TRAFFIC ENGINEERING AND CORRESPONDENCE

TE KOWHAI MIXED USE COMMERCIAL DEVELOPMENT - TRANSPORTATION REVIEW

TE KOWHAI VILLAGE COMMERCIAL DEVELOPMENT

Figure 2: Proposed site layout (larger copy attached at Appendix A)

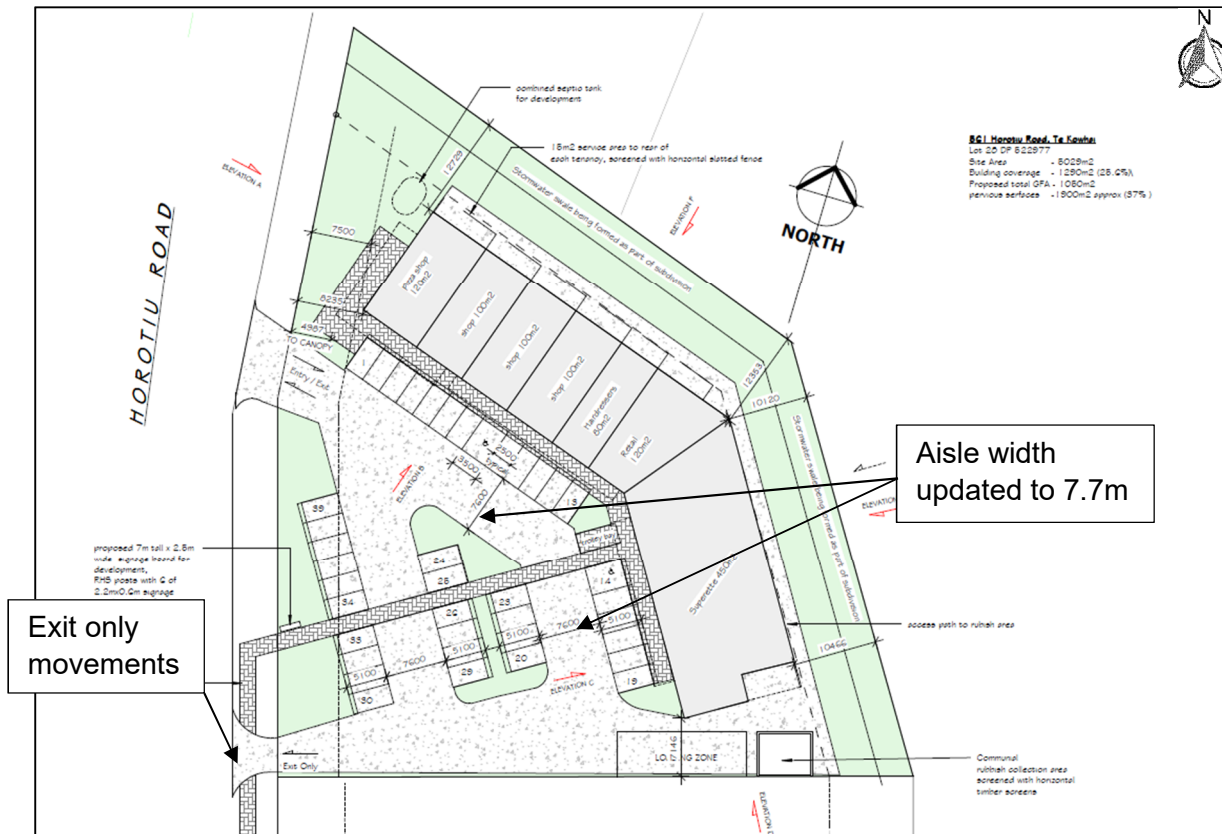
The proposal includes two new vehicle crossings on Horotiu Road. The ITA states that the southern vehicle crossing will be restricted to exit only movements for service vehicles (e.g. delivery vehicles and refuse collection vehicles). The proposed layout is shown in Figure 2.

We are concerned that the proposal does not adequately manage the southern exit vehicle crossing to service vehicle use only. There is a risk that the exit only vehicle crossing will be used by general visitors in particular vehicles turning left out of the development as there is no physical barrier stopping the use of this vehicle crossing. There is also a risk that vehicles may right turn into the site via the southern vehicle crossing.

There are likely to be adverse safety and efficiency effects related to increased movements at the vehicle crossing compared to a layout with a single vehicle crossing and if the vehicle crossing was only used by existing service vehicles. No sign layout has been provided to demonstrate that the crossing will only be used by exiting service vehicles. We consider it very unlikely that signs and markings will be effective in limiting movements to existing service vehicles and consider that the crossing is assessed as an all movements crossing.

Figure 3: Semi-trailer swept paths

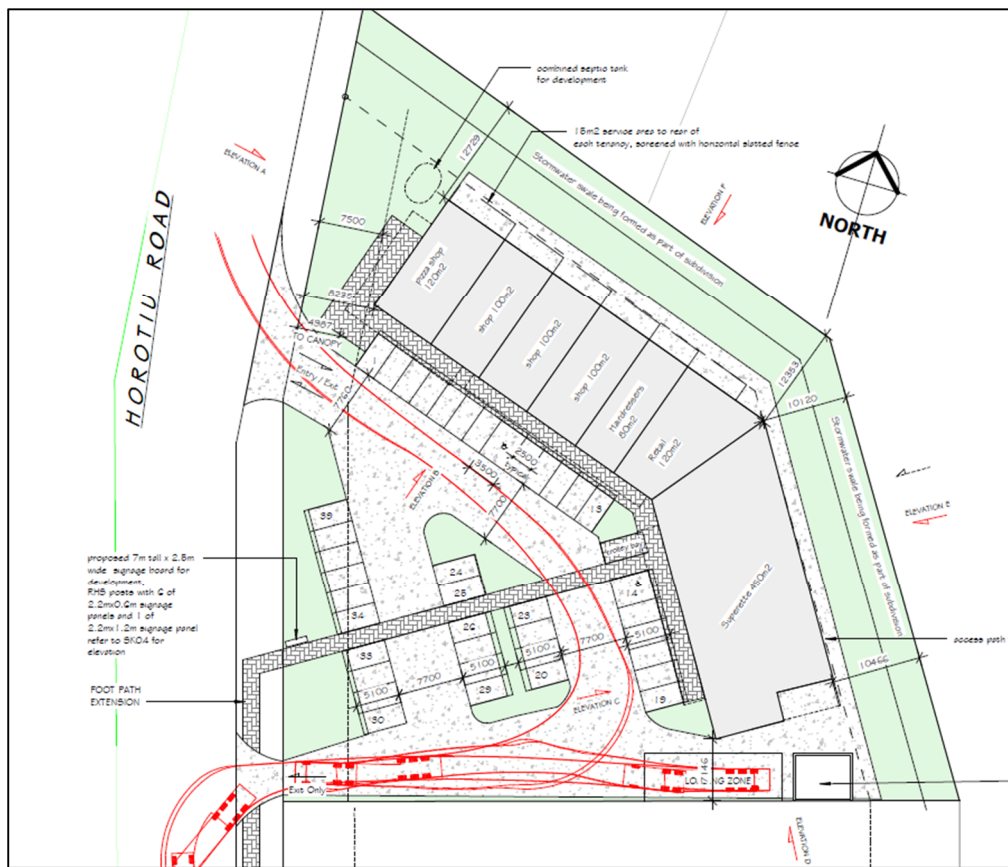
Following our further information request swept paths have been provided for a semi-trailer entering the site parking within the loading space and exiting the site via the exit only vehicle crossing. We note that the required clearance (300mm) for the swept paths is not shown on the drawings. There are some locations where it appears that adequate clearance may not be achieved and damage to the kerbs within the site may result. We recommend providing clearance minimum 300mm clearance from vehicle body to kerbs.

Figure 6: Pedestrian Connection on Horotiu Road

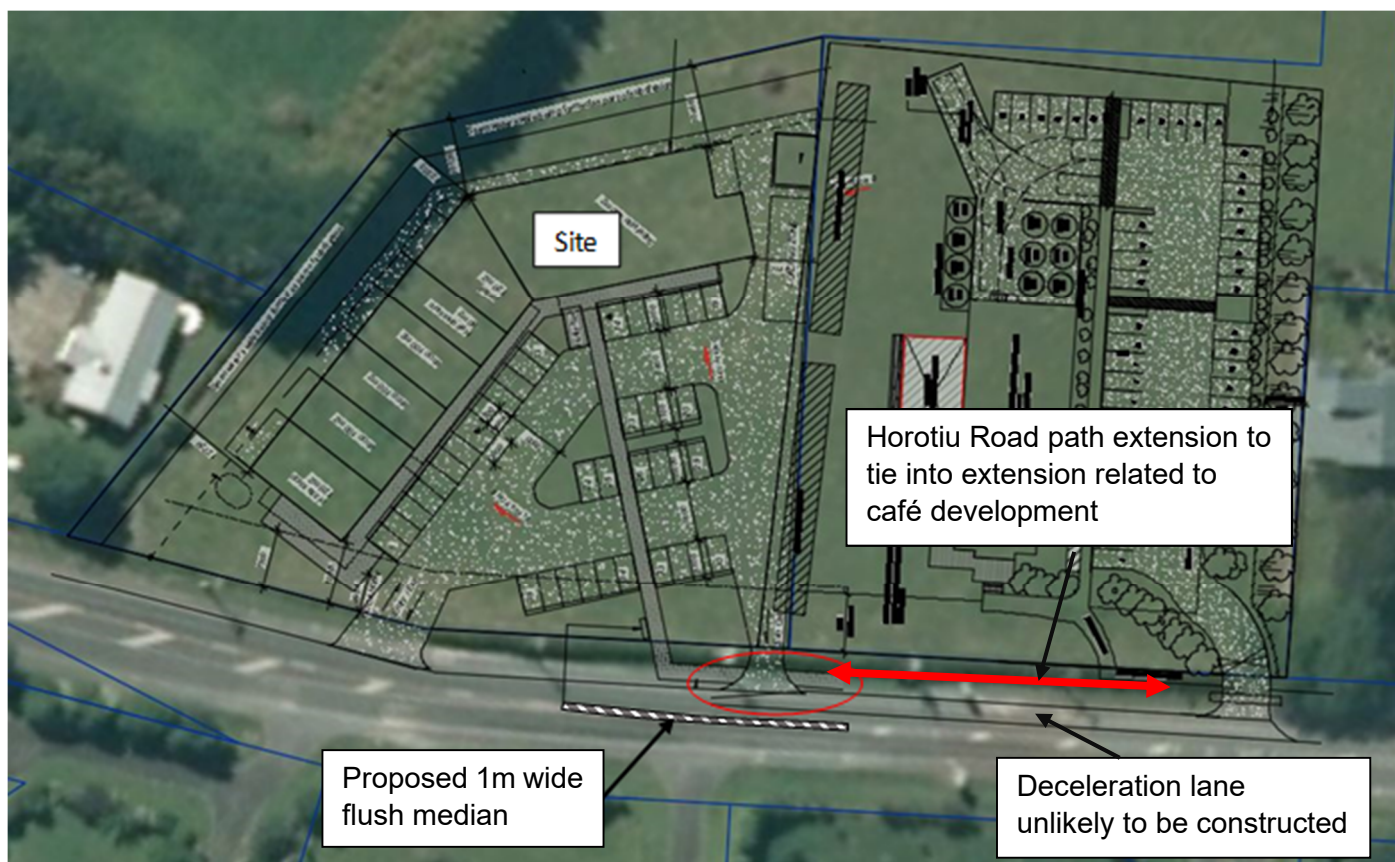
The plans show a footpath extension from the shop frontage though the car park and onto Horotiu Road. We support a pedestrian connection to Horotiu Road. The plans indicate a path stopping just south of the southern vehicle crossing. We recommend that a continuous footpath is provided and that this development is required to extend the path from the café development to this site. The path extension related to the café is shown right up against the boundary. It would be desirable to form the path up against the boundary as well.

Figure 7: Austroads Turning warrants

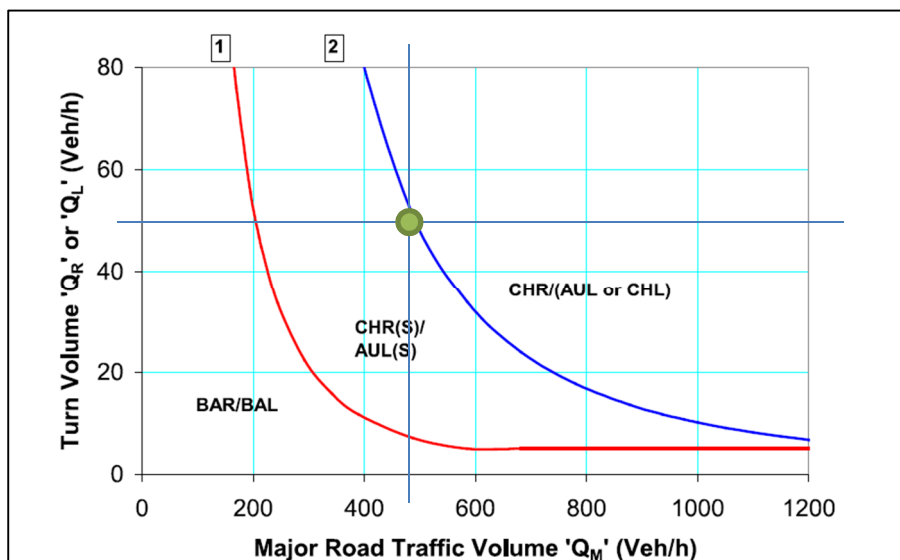
Austroads provides guidance on turning warrants. Based on all vehicles accessing the site via the northern vehicle crossing. We anticipate 50 veh/hr turning right at the vehicle crossing during peak hour. As shown below, based on anticipated right turning volumes and 500 veh/hr² on Horotiu Road a channelised right turn treatment is warranted. If right turns in are only 50% or 25veh/hr, a short right turn treatment is still required.

Given the 50km/h posted speed a 2m wide flush median is recommend. A 2m wide flush median is sufficient for sheltering a light vehicle waiting to right turn into the development. We recommend providing a 2m wide minimum flush median on Horotiu Road at both vehicle crossings as there is a risk that the proposal does not adequately manage the southern vehicle crossing to exit only movements. The flush median will assist with speed management on Horotiu Road and provide consistency of treatment on Horotiu Road.

Figure 8: Horotiu Road Layout (yellow star = proposed vehicle crossings)

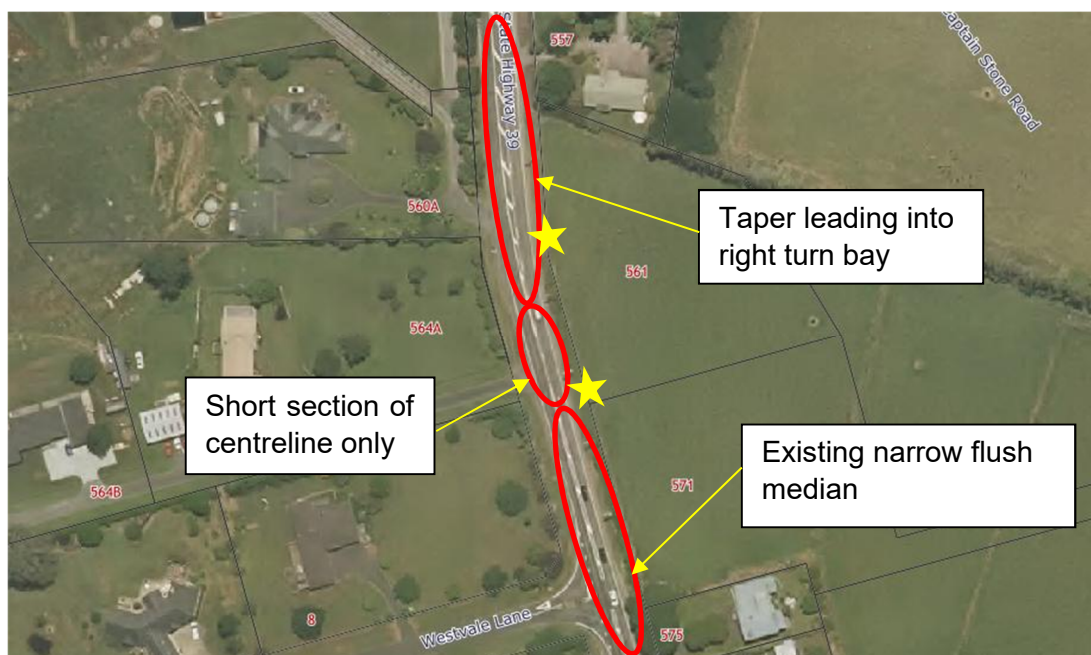
There is an existing right turn bay at the Horotiu Road/Ngaruawahia Road intersection, the taper begins outside this site. A narrow flush median commences on the southern boundary with a centreline provided between the flush median and the right turn bay taper which extends south towards the Te Kowhai Village.

The existing seal width on Horotiu Road outside the development is approximately 10.9m³. A desirable turning facility would be 3m wide. Providing a turning facility in this location based on the existing carriageway width would result in narrow shoulders which would be undesirable. Pavement widening would be required to accommodate a 3m right turn facility.

Pavement widening (approximately 1m) will be required to ensure that minimum 3.5m lanes, 1.5m shoulder and 2m wide flush median can be provided at the vehicle crossing. The flush median should be designed in accordance with MOTSAM and current design best practice.

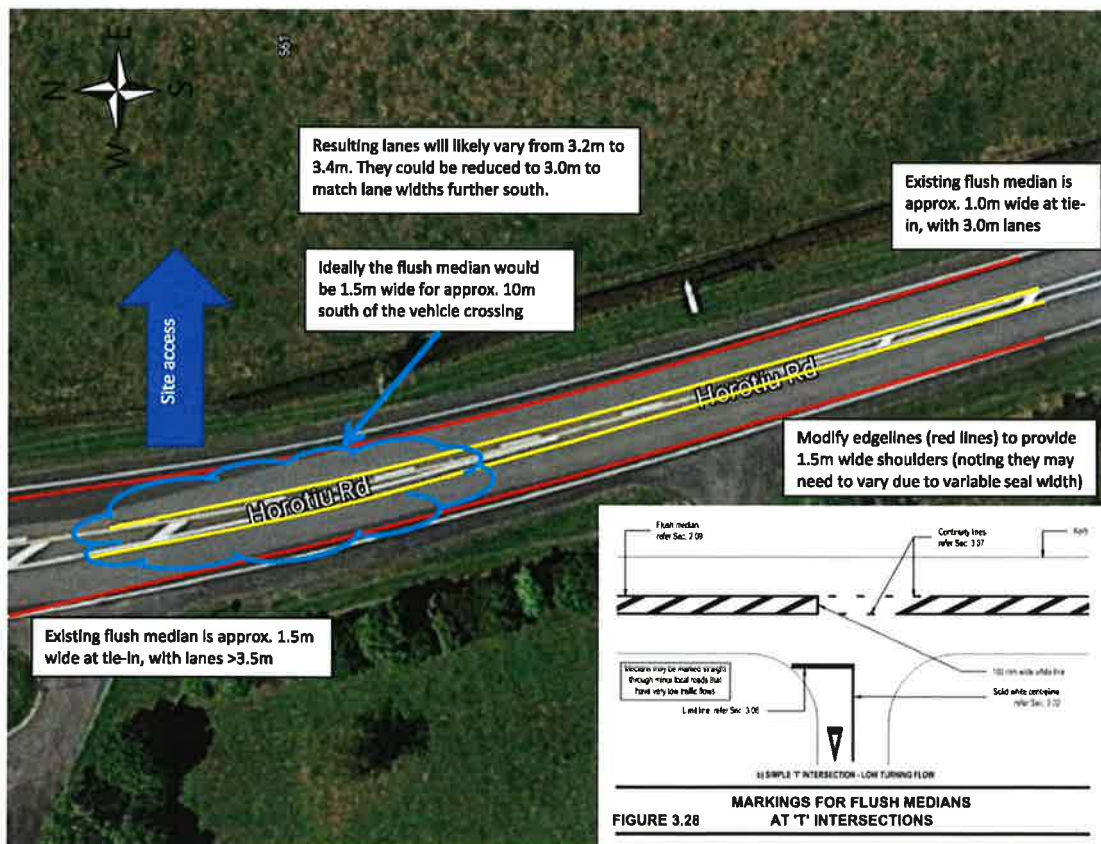
Its also complicated by the site access being located where the markings for the right-turn bay begin and being on a curve. I have attached a sketch on how I see the layout working. The key dimensions are:

- 1.5m flush median at the site access
- 1.5m shoulders
- Lanes approx. 3.2m once the median and shoulders are setout (but may narrow to 3.0m due to the variable seal width)

To help define the site access, I recommend that the median is marked with a break as shown in MOTSAM, Part 2 Markings, Figure 3.28 copy (included on the attached sketch).
